**TOWN OF MOUNTAIN VILLAGE
REGULAR DESIGN REVIEW BOARD MEETING AGENDA
THURSDAY SEPTEMBER 7, 2023, 10:00 AM
MOUNTAIN VILLAGE TOWN HALL
455 MOUNTAIN VILLAGE BLVD, MOUNTAIN VILLAGE, COLORADO
TO BE HELD HYBRID THROUGH ZOOM:
<https://us06web.zoom.us/j/81245118996>
Meeting ID: 812 4511 8996**

**DESIGN REVIEW BOARD MINUTES
TOWN OF MOUNTAIN VILLAGE
REGULAR DESIGN REVIEW BOARD MEETING
SEPTEMBER 7, 2023**

AGENDA ITEM 8
PLANNING & DEVELOPMENT SERVICE
PLANNING DIVISION
455 Mountain Village Blvd.
Mountain Village, CO 81435
(970) 728-1392

2 ADDRESS MONUMENT ELEVATION
A4.05 SCALE : 1 1/2" = 1'-0"

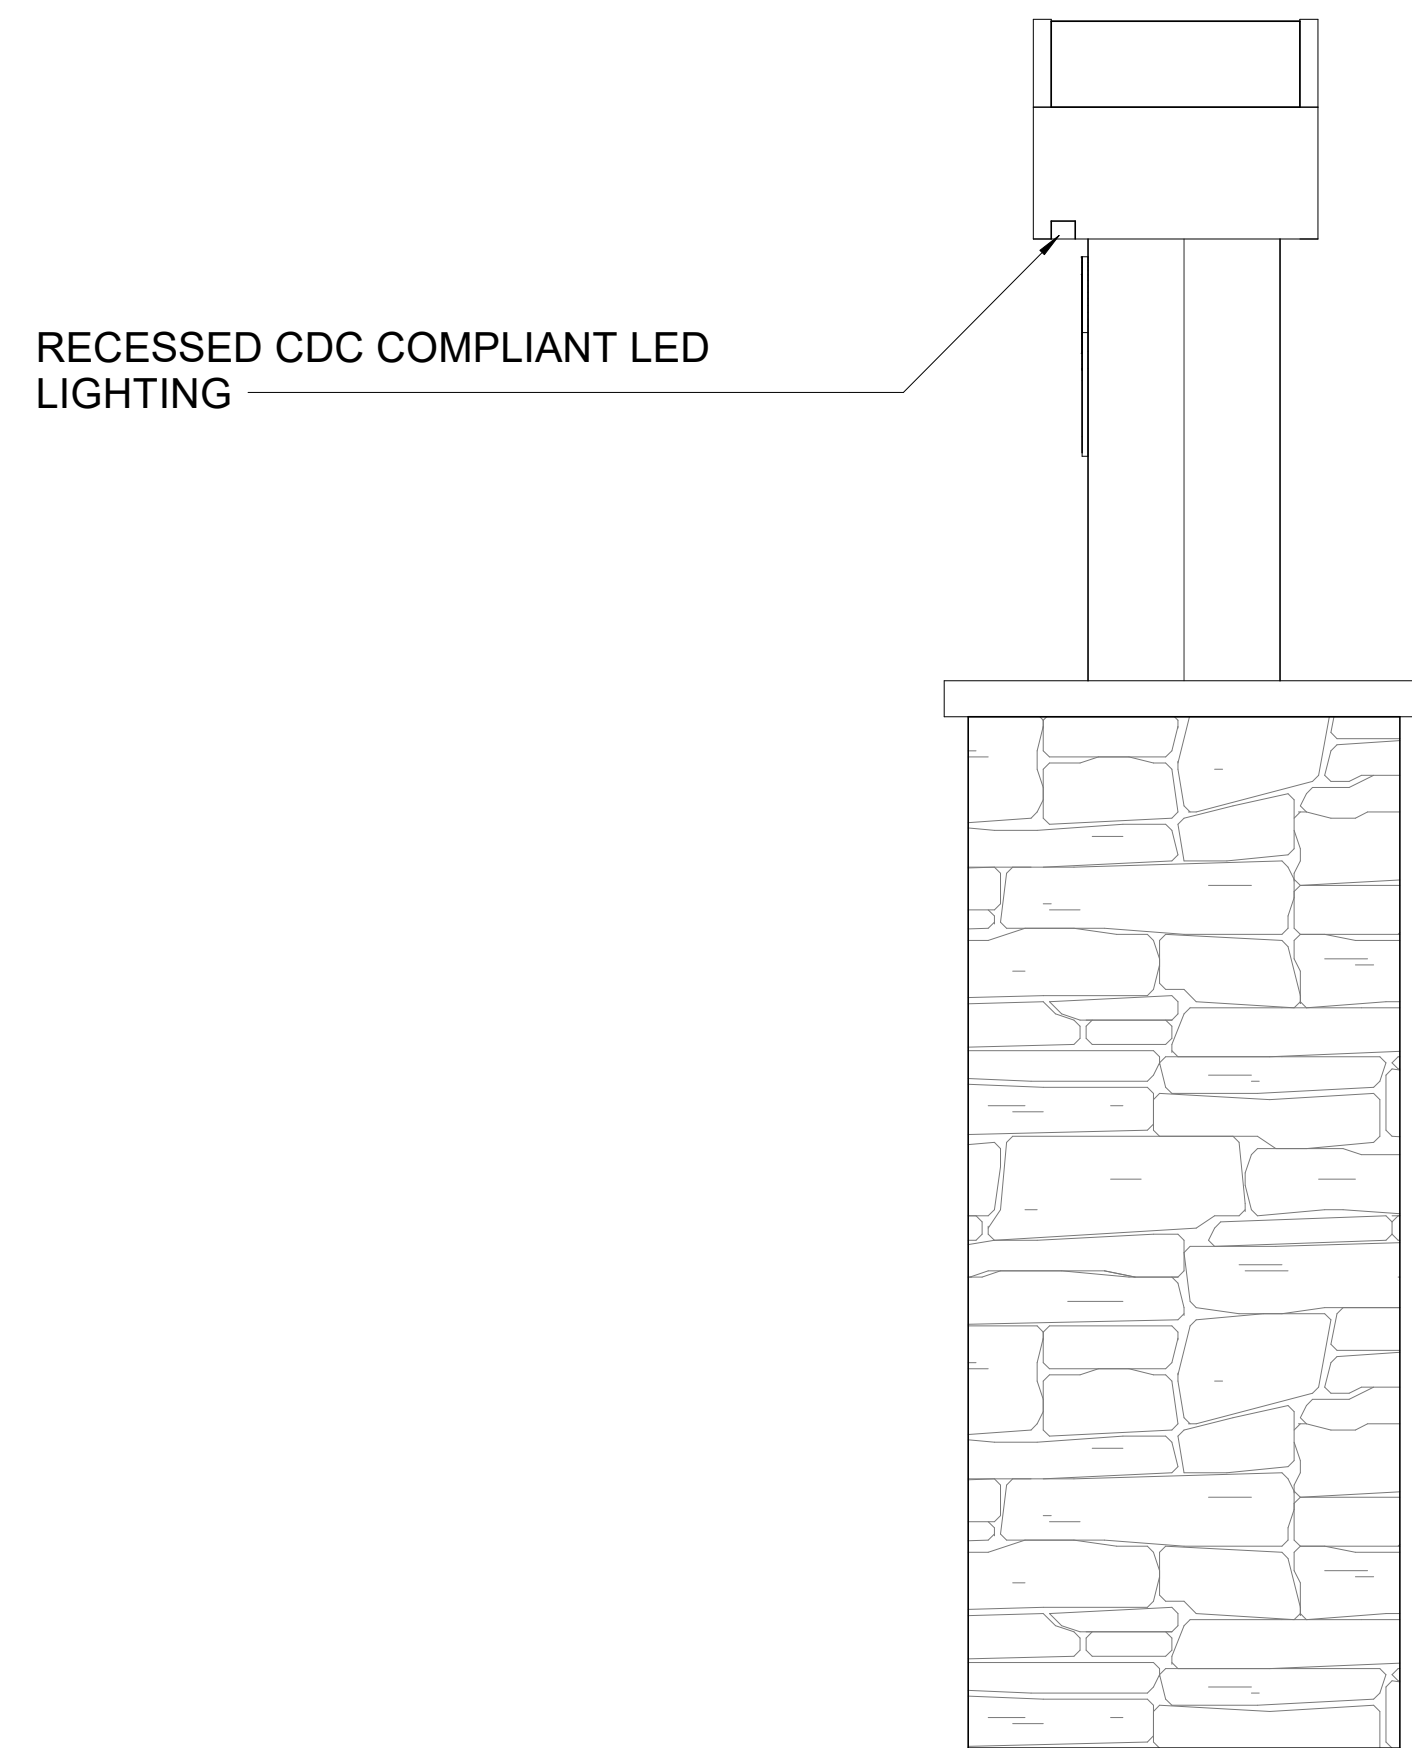
16) Prior to final review, the applicant must provide a revision of the address monument without board form concrete.

- 8) Prior to final review, the applicant shall provide material and dimension information for the address monument. The address numbers shall be a minimum of 4-foot 6-inches from grade to the bottom of the address numbers. Address numbers shall be 6-inches in height, reflective coated, or outlined with a reflective coating.

Site Grading with Driveway Profile

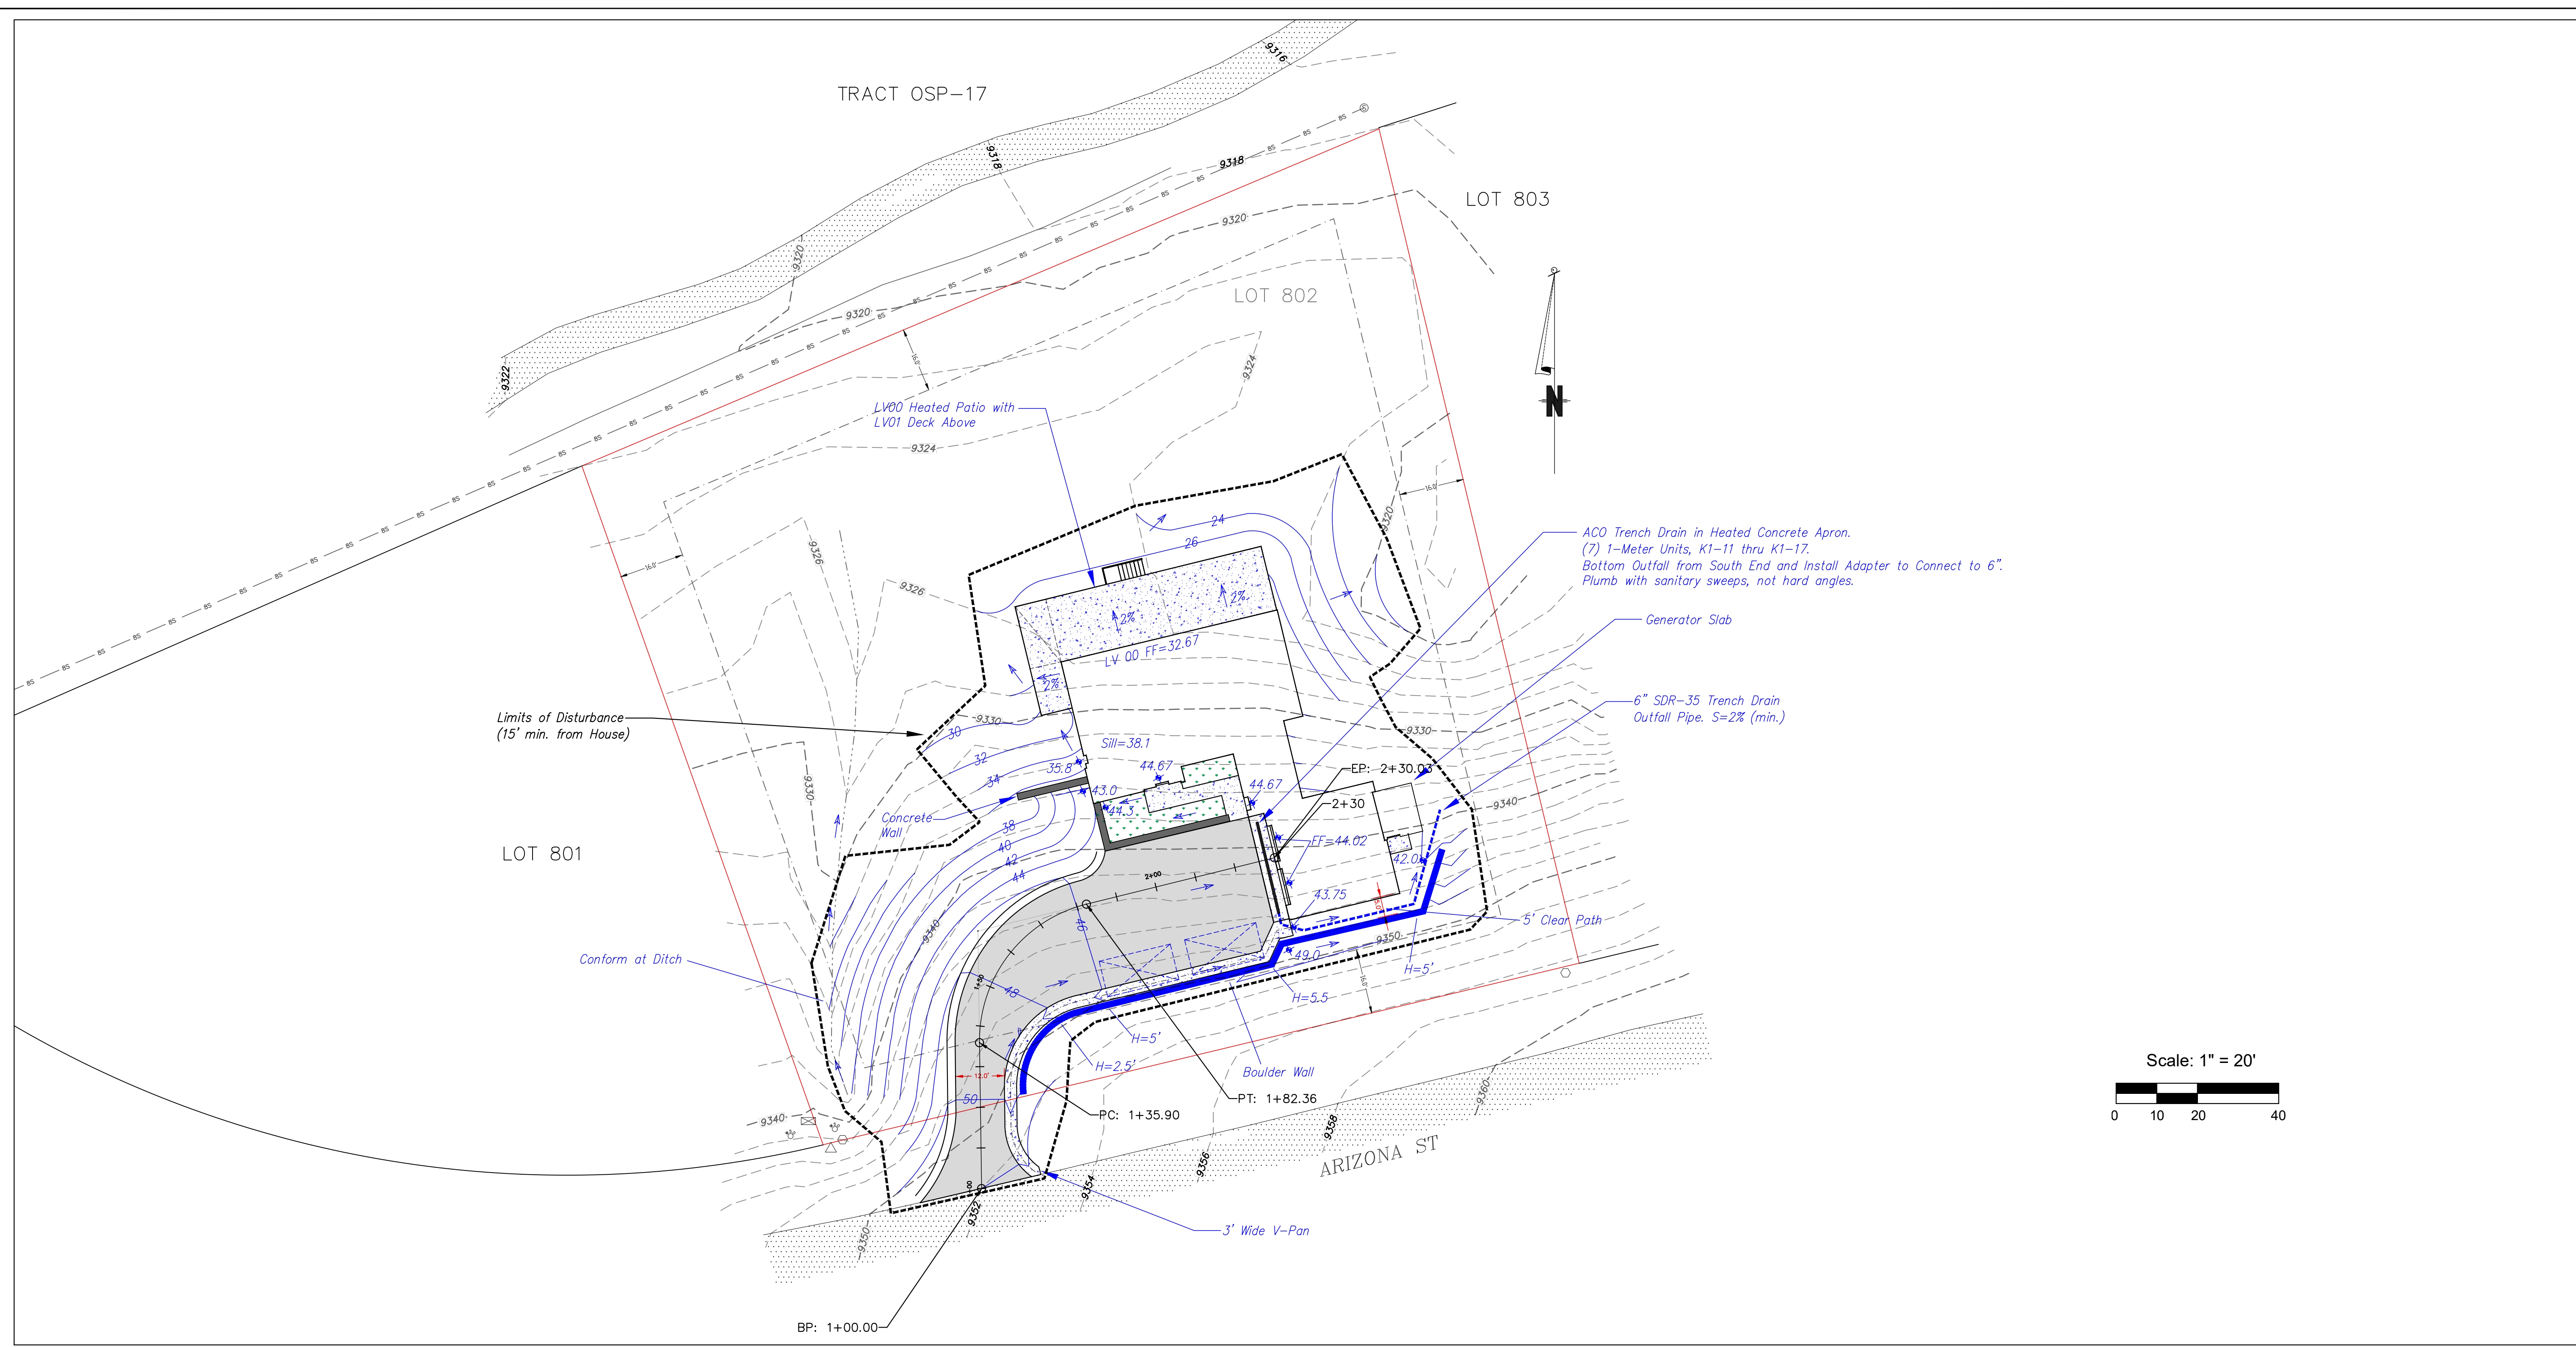
Staff: The lot does not have ponds, streams, or wetlands. The applicant proposes to build a retaining wall adjacent to the driveway that crosses the southern portion of the existing seasonal drainage swall. This could impede drainage flow from the south to the north (see Sheet A1.1). The applicant shall clarify if there is a planned trench drain or other means of allowing seasonal drainage through retainage. This is required for final review.

Staff: A grading plan is provided on Sheet C2.1. The site has significant grade change that slopes from the south to the north. Most of the southern portion of the site contains areas that are 30 percent slope. Grading is proposed downslope from the driveway and to the
